# NATIONAL CONSTRUCTION CODE REPORT

RESIDENTIAL DEVELOPMENT

116-120 FRENCHS FOREST RD WEST & 11 GLADYS AVE  
FRENCHS FOREST

7 APRIL 2024

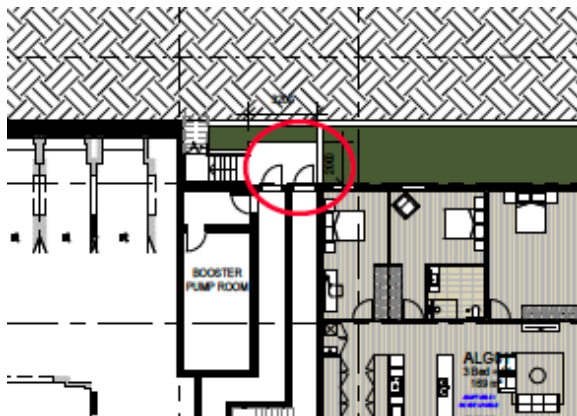
- The travel distance to the first exit on the basement level 1 exceeds 40m permitted (up to 53m).
- The travel distance to the first exit on the basement level 1 exceeds 40m permitted (up to 53m).

These non-compliance with the Deemed To Satisfy provisions will be subject to an performance solution to address the relevant Performance Requirements of the BCA.
